REPORT AMENDED BY STAFF 2-26-87  
**CITY PLANNING COMMISSION**

- APPLICATION:**
- A. Negative Delcaration
  - B. Amend Sunset Meadows PUD Schematic Plan to designate a church site in place of Single Family Residential for 12.3 ± acres
  - C. Special Permit to construct a 2 Phase church project with a total of 39,690 square feet of building, 560 fixed seats and 1,842 total seats in the Townhouse PUD (R-1A-PUD) Zone.
  - D. Variance to exceed 35 feet height limit by 11 feet.

**LOCATION:** North side Rio Tierra Avenue 600± feet west of Northgate Boulevard.

**PROPOSAL:** The applicant is requesting the necessary entitlements to construct a 2 phase church with a total of 39,690 square feet of building area, 560 fixed seats and 1,842 total seating capacity.

**PHASE I BUILDING ELEVATIONS**  
 SCALE: 1/8"=1'-0"

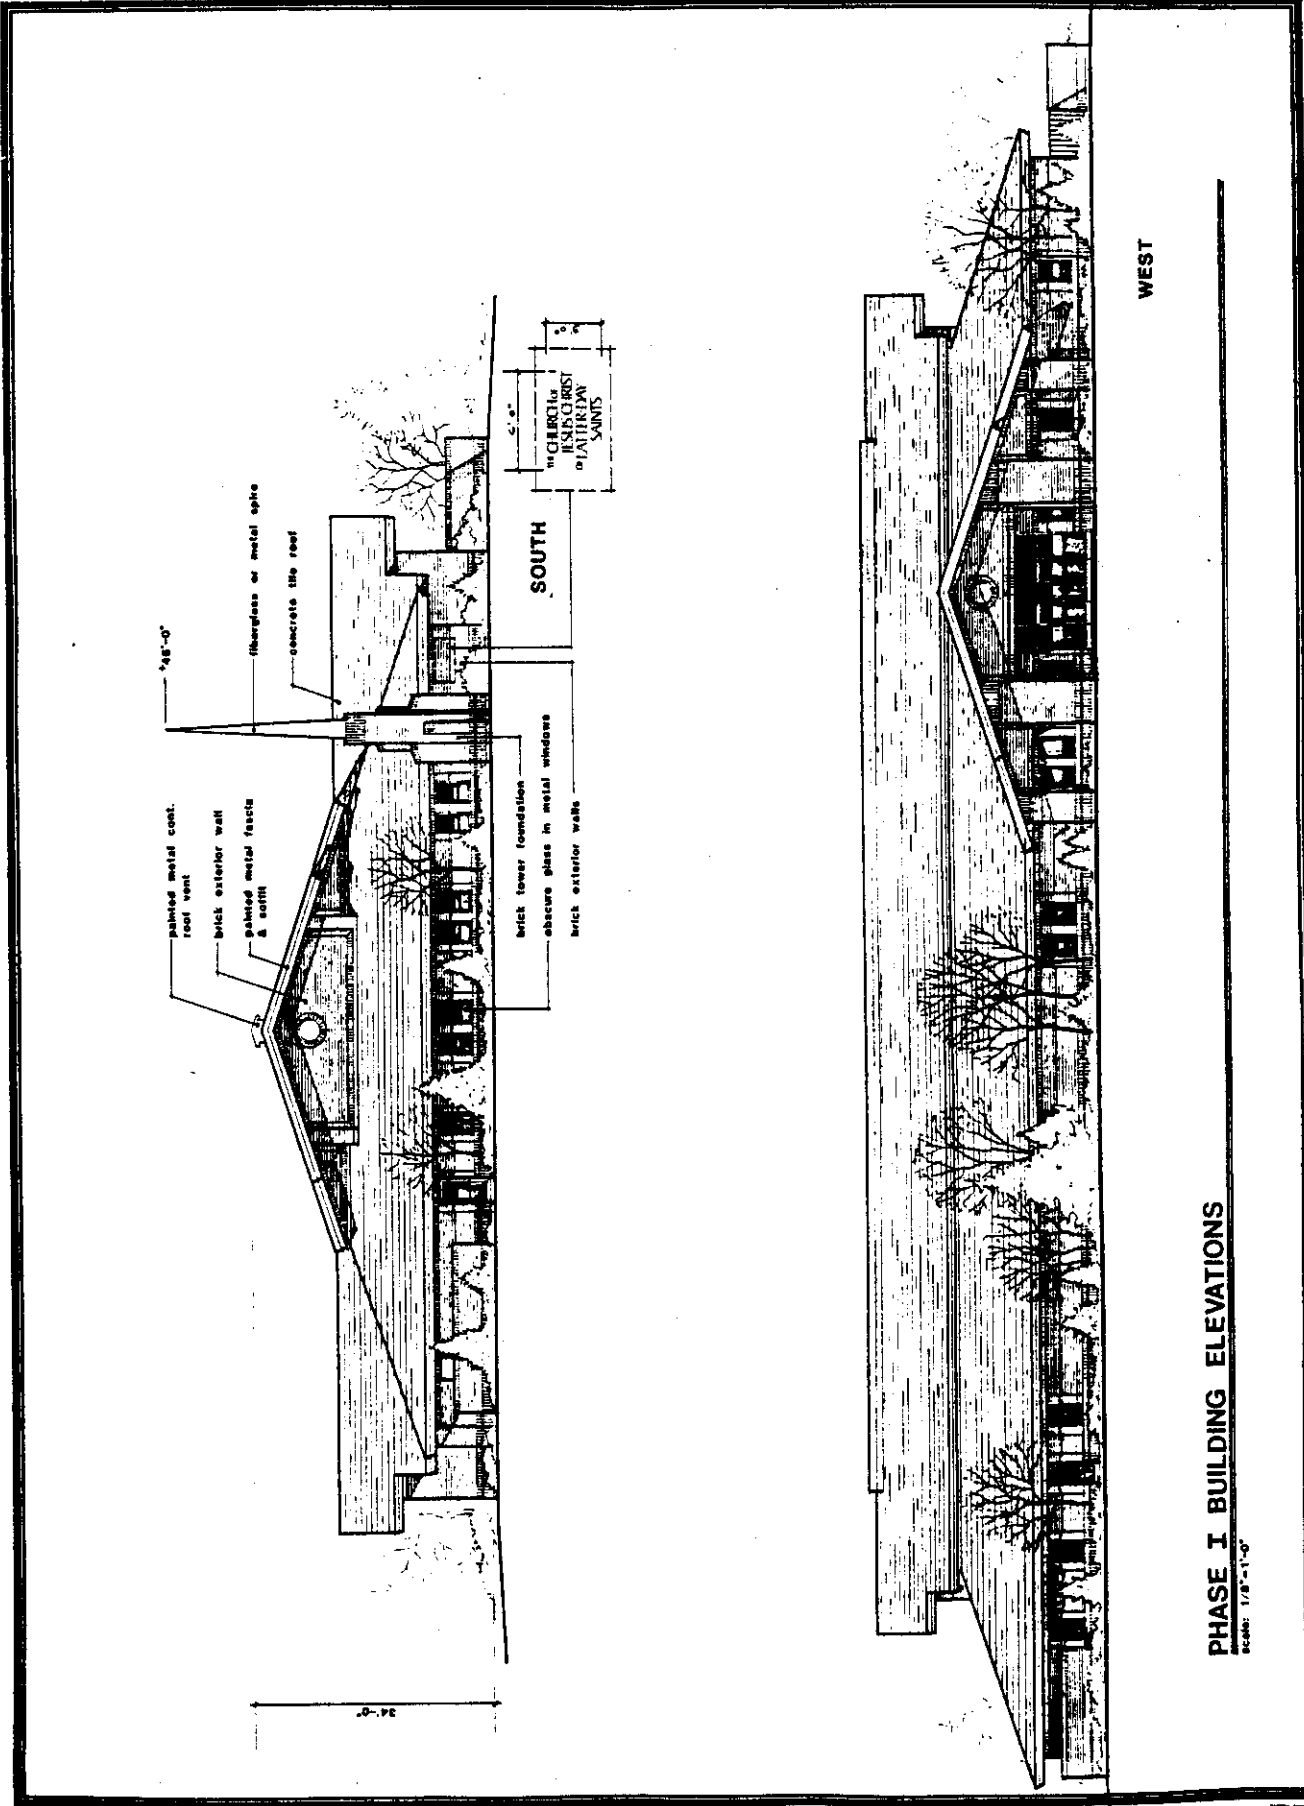
As a detached structure, the circumstance for considering the height variance is unique. Prior consideration by the Commission on similar requests for church spires were attached to the roof, not a detached structure. Staff observes that the function is similar to a flag pole indicating a specific location and use. The proposed spires are architecturally compatible with the main buildings. Staff concurs with the applicant's statement that spires are found with church developments and that their design will enhance building identification for church members. Since the function of the detached spire is similar to the attached spire referenced in the Zoning Ordinance, and the 42 foot height limit is proposed to be exceeded by 4 feet, staff anticipates no problem in supporting the height variance for both spires.

Staff recommends that the foundations for the spires be located behind the building setback line of 25 feet from the public right-of-way along Rio Tierra Avenue.

21. The spires shall be set back a minimum of 25 feet from the public right-of-way.
22. The spires shall not be illuminated, either externally or internally.
